YEAR 6 (2021) MONITORING REPORT
AYCOCK SPRINGS
STREAM AND WETLAND MITIGATION SITE

ALAMANCE COUNTY, NORTH CAROLINA
DMS PROJECT No. 96312
FULL DELIVERY CONTRACT No. 5791
NCDWR PROJECT No. 20140335
USACE ACTION ID No. SAW-2014-01711

Response to Monitoring Year 6 (2021) DMS Comments

Aycock Springs Stream and Wetland Mitigation Site (DMS #96312)
Cape Fear River Basin 03030002, Alamance County
Contract No. 005791

Figure D1: Aycock Springs 30-70 Percentile Graph for Rainfall

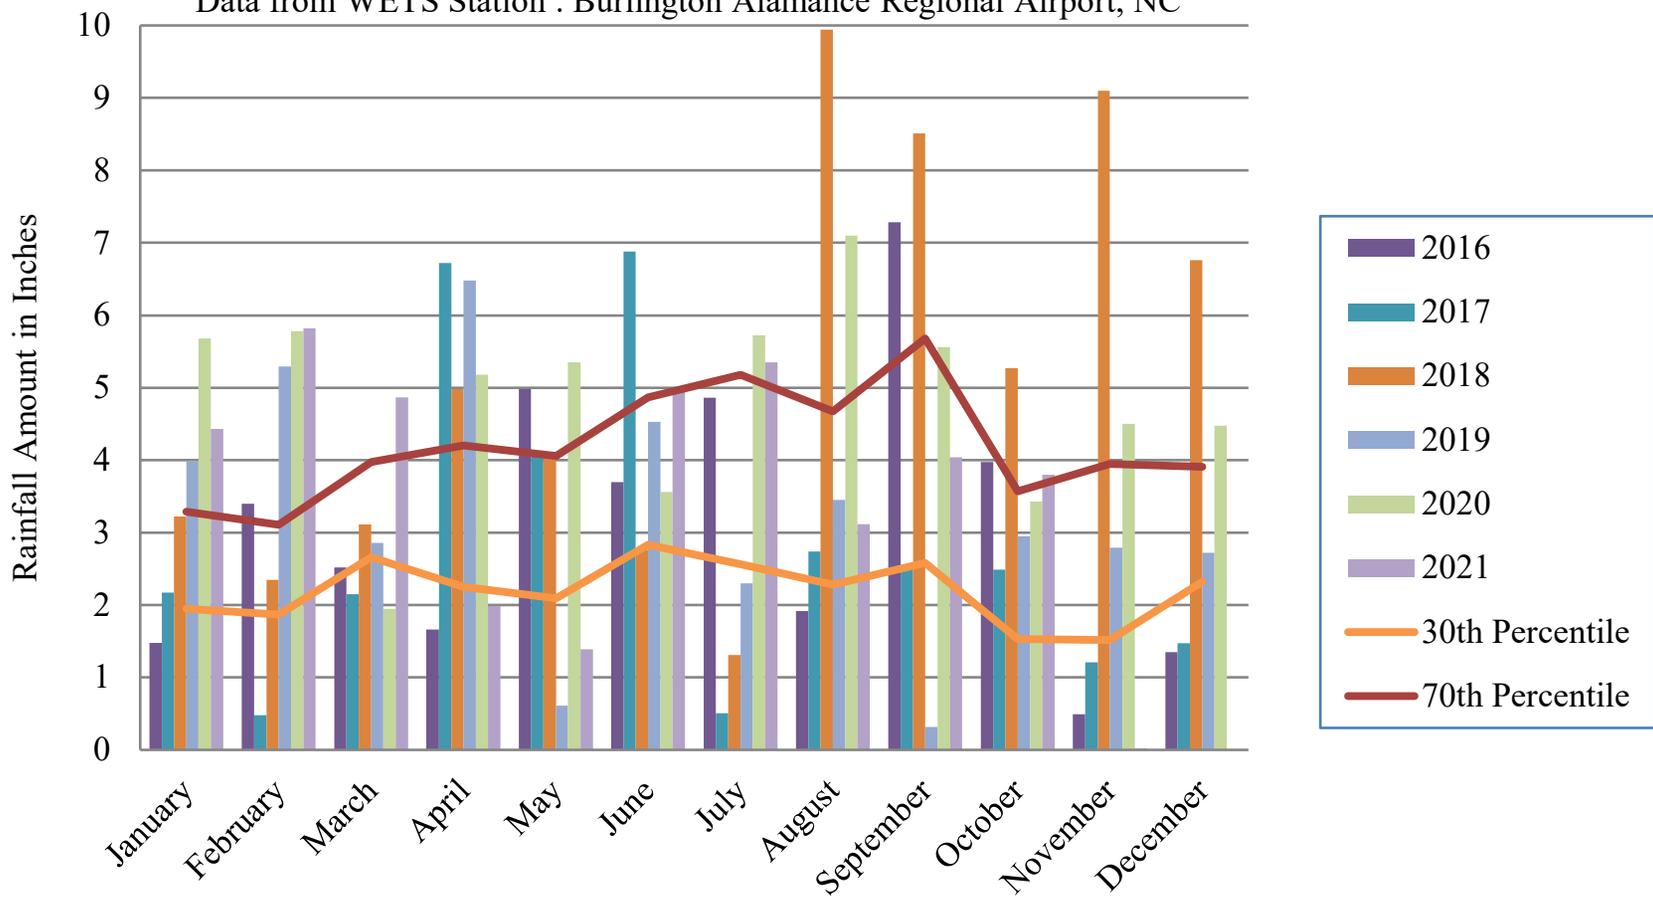
5. Please include a figure displaying the monthly rainfall data compared to 30-70th percentiles
[Figure D1: 30-70 Percentile Graph for Rainfall was included in appendix D.](#)
